To: Mayor and Council
From: Sharon Hvozdanski, Director of Planning
Date: June 2, 2016
Subject: Subdivision and Development Variance Permit Application
Files: SUB00734; DVP00371 • 3171 & 3181 Kingsley Street

Project Proposal: The applicant is requesting three variances to accommodate a lot consolidation and boundary adjustment subdivision to create two lots, from three existing lots, under the current RS-6 zoning. The variances requested are combined side yard setback and non-basement area for the existing dwelling, and height for the proposed dwelling.

To: Subdivision Office
From: Jagtar Bains – Development Coordinator
Date: December 17, 2014
Subject: Servicing Requirements for Development

**PROJECT: LOT CONSOLIDATION AND BOUNDARY ADJUSTMENT SUBDIVISION TO
CREATE TWO LOTS FROM THREE EXISTING LOTS UNDER CURRENT RS-6**

Figure 2: Proposed Subdivision

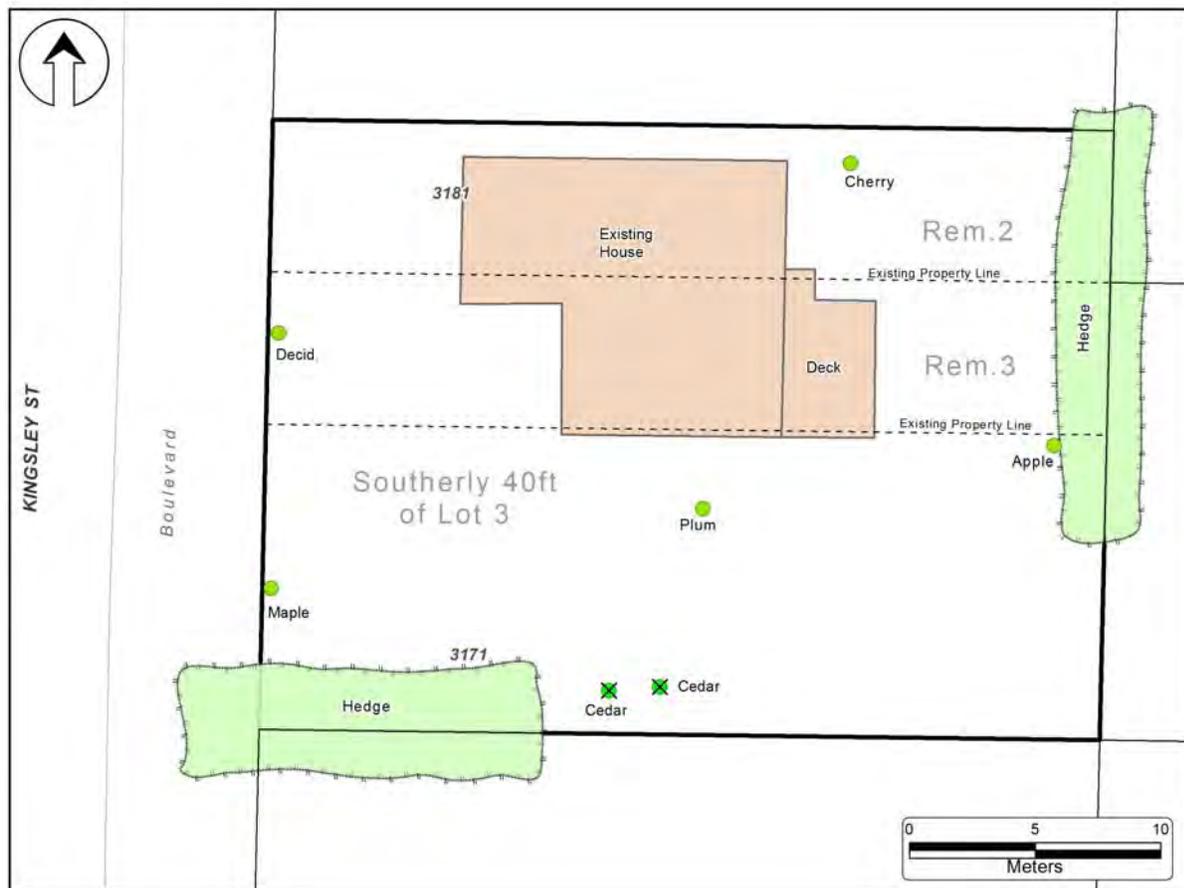
The subject proposal meets the requirements of Section 5.2 of the Subdivision Bylaw. By eliminating one of the interior lot lines and moving the other farther south, the end result would be one less parcel and both of the subsequent parcels would be larger in area and wider than the smallest original parcel. A subdivision application under this Section of the Subdivision Bylaw does not require Council approval, it is strictly under the purview of the Approving Officer. However, in this instance, the applicant is requesting variances in order to retain the existing dwelling and to achieve a viable building envelope for the proposed new dwelling. The proposed variances are discussed further in this report.

To eliminate the encroachment of the existing dwelling over the existing property lines, the applicant proposes to adjust the southerly interior lot line to create proposed Lot B with an area of 335.1 m² and a width of 10 m. The remainder Lot A would have an area of 482.4 m² and lot width of 14.4 m. The existing dwelling would remain on Lot A. The applicant has provided a conceptual dwelling design for proposed Lot B.

Figure 5: Conceptual Dwelling Design Proposed Lot B (Plans prepared by Cumming Design)

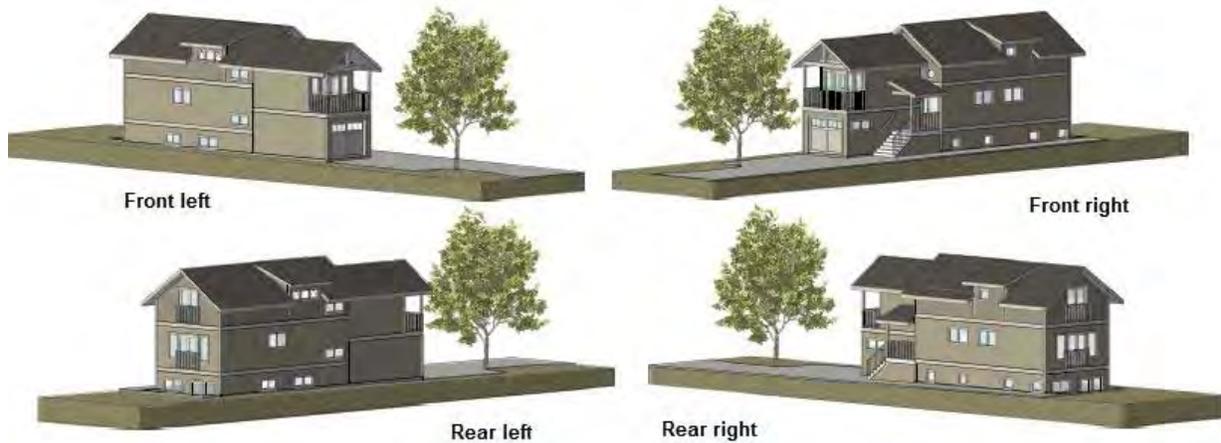
The proposed new dwelling is designed with an attached single car garage extending beyond the main building face and entrance, a design feature that is typical of newer homes. The main pedestrian entrance is stepped back from the front façade but features an enhanced covered area. As well, to reduce the visual impact of the vehicle entrance, the applicant proposes an open deck above the garage (see Figures 4 and 5).

As per Section 5.27 of the Zoning Bylaw, dwelling height is restricted to 6.0 m for sloped roofs for those lots with an area less than 446 m² or a width of less than 13.5 m. Proposed Lot B falls within these parameters. To accommodate a solar panel in the future and to provide natural light on the upper floor, a shed dormer is proposed on the southerly (right) roof structure (see Figure 5). With the addition of the shed roof, the proposed height of the dwelling is 6.4 m, 0.4 m over the permitted height. Although a dwelling could be designed to meet the height restriction, designing one to accommodate a future solar panel would be difficult. It is for that reason the height variance can be supported.

If this development application is supported by Council, a covenant to require that the siting and design of a new dwelling on proposed Lot B conforms to the conceptual plans presented by the applicant should be secured prior to the issuance of the Development Variance Permit.

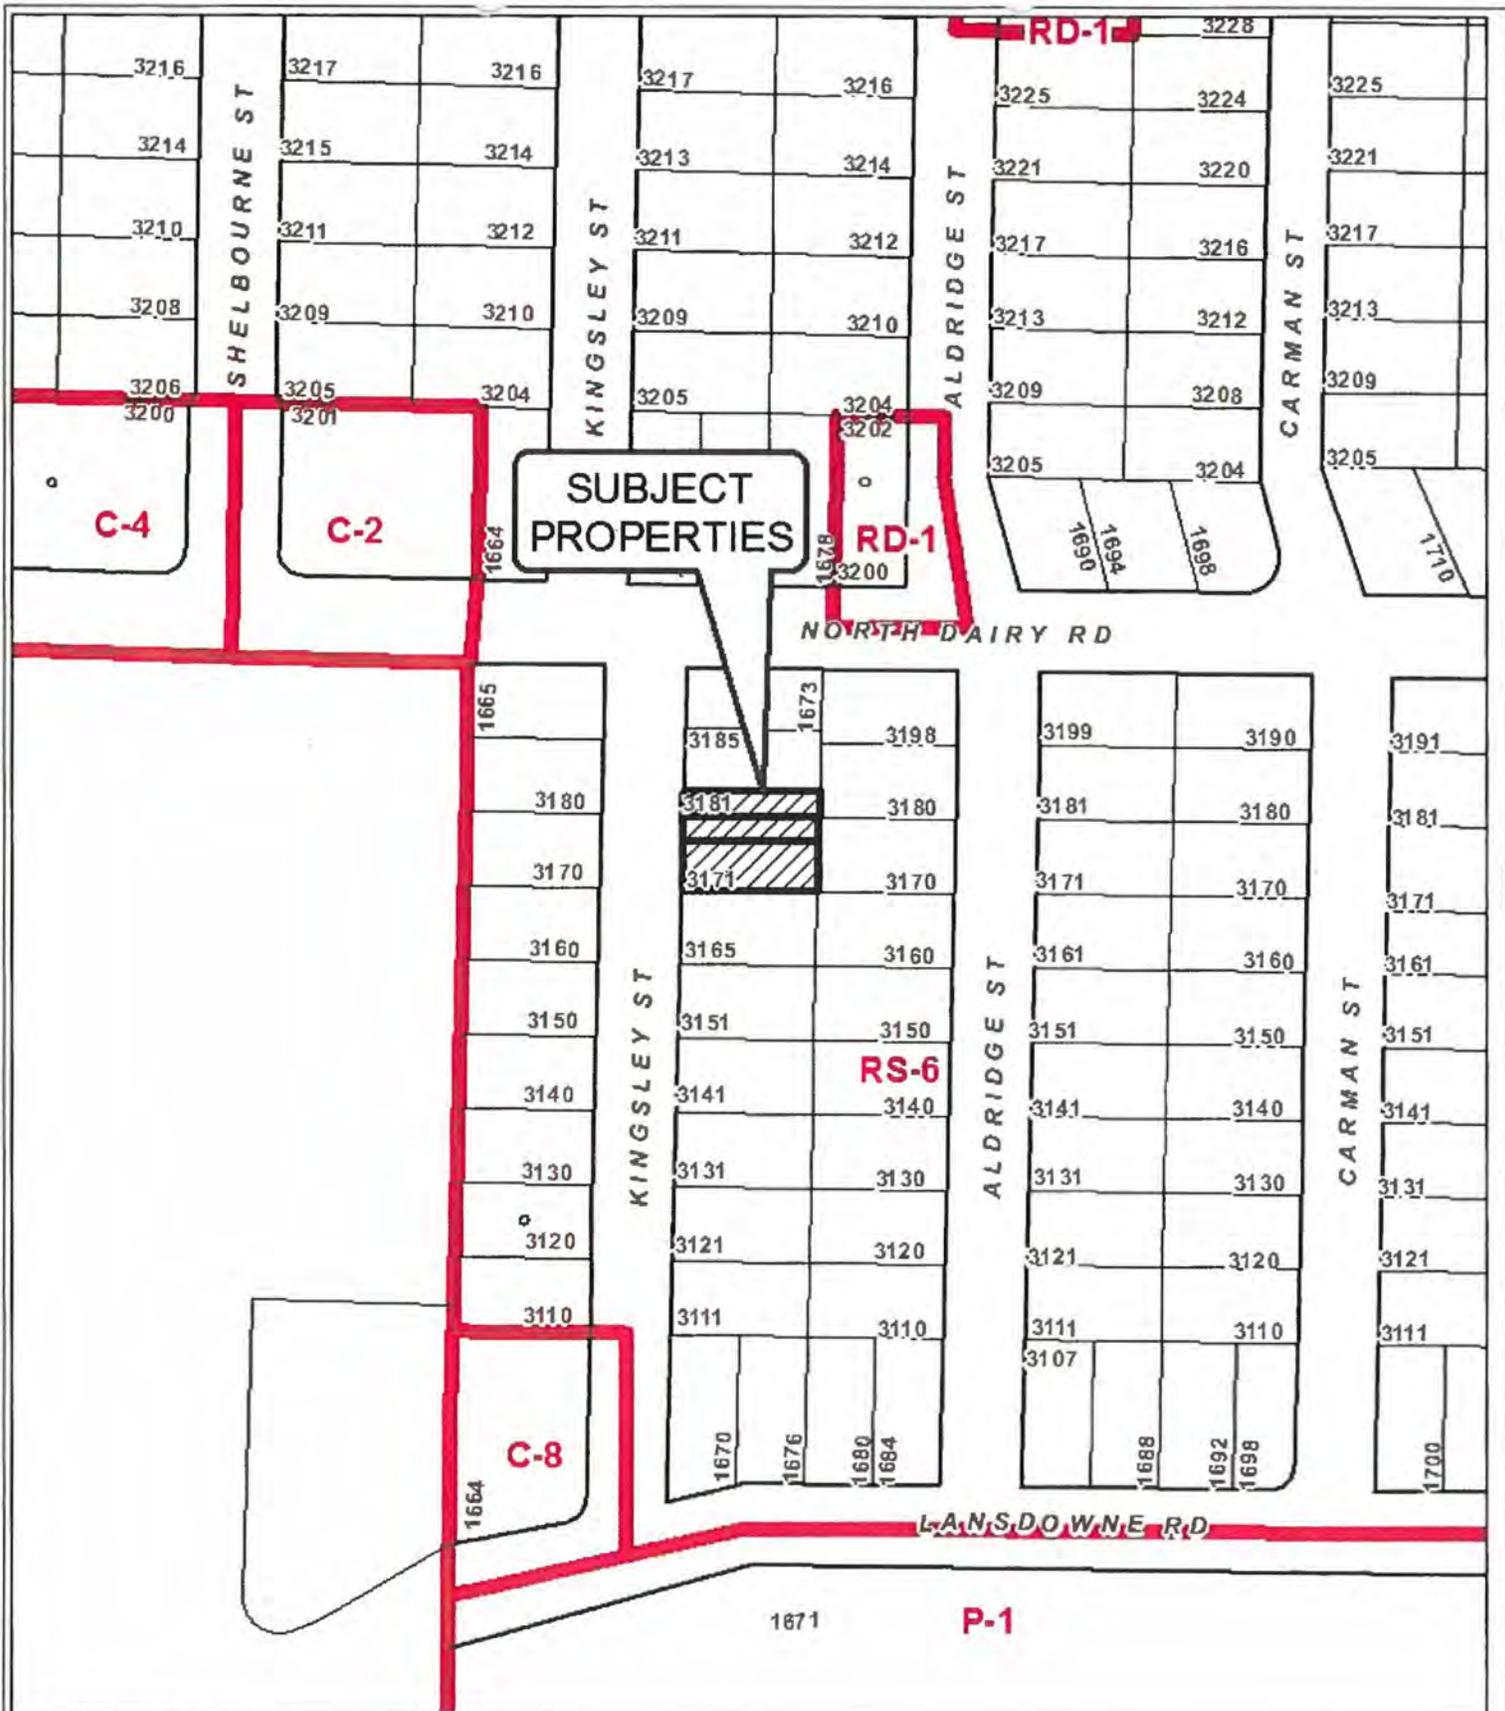
1. STORM WATER MANAGEMENT MUST BE PROVIDED FOR PROPOSED LOTS A AND B IN ACCORDANCE WITH THE REQUIREMENTS OF SCHEDULE H "ENGINEERING SPECIFICATIONS" OF SUBDIVISION BY-LAW. THIS SUBDIVISION IS WITHIN TYPE II WATERSHED AREA WHICH REQUIRES STORM WATER STORAGE, OIL/GRIT SEPARATOR OR GRASS SWALE AND SEDIMENT BASIN. FOR FURTHER DETAILS, REFER TO SECTION 3.5.16, STORM WATER MANAGEMENT AND EROSION CONTROL OF SCHEDULE H "ENGINEERING SPECIFICATIONS" OF SUBDIVISION BY-LAW.
2. THE EXISTING, MOST SOUTHERLY CONNECTION, IS TO BE USED BY PROPOSED LOT B. A PRIVATE EASEMENT IS REQUIRED ACROSS THE CORNER OF PROPOSED LOT A IN FAVOR OF PROPOSED LOT B.
3. THE EXISTING CONNECTIONS, WHICH ARE TO BE USED BY PROPOSED LOTS A AND B, ARE TO BE PROVIDED WITH INSPECTION CHAMBERS.

1. THE CHIMNEY ON THE NORTH SIDE OF THE EXISTING HOUSE MUST BE REMOVED PRIOR TO SUBDIVISION APPROVAL.

1. THE EXISTING HOUSE CONNECTION FOR PROPOSED LOT A MUST BE PROVIDED WITH AN INSPECTION CHAMBER.
2. SUBSEQUENT SEWER CONNECTION B WILL BE REQUIRED FOR PROPOSED LOT B FROM THE EXISTING MAIN KINGSLEY STREET.

1. A FIRE HYDRANT WILL BE REQUIRED.
2. PROVISIONAL WATER CONNECTION WILL BE REQUIRED FOR PROPOSED LOT B.
3. THE EXISTING 13 MM WATER SERVICE TO PROPOSED LOT A, MUST BE UPGRADED TO 19 MM.
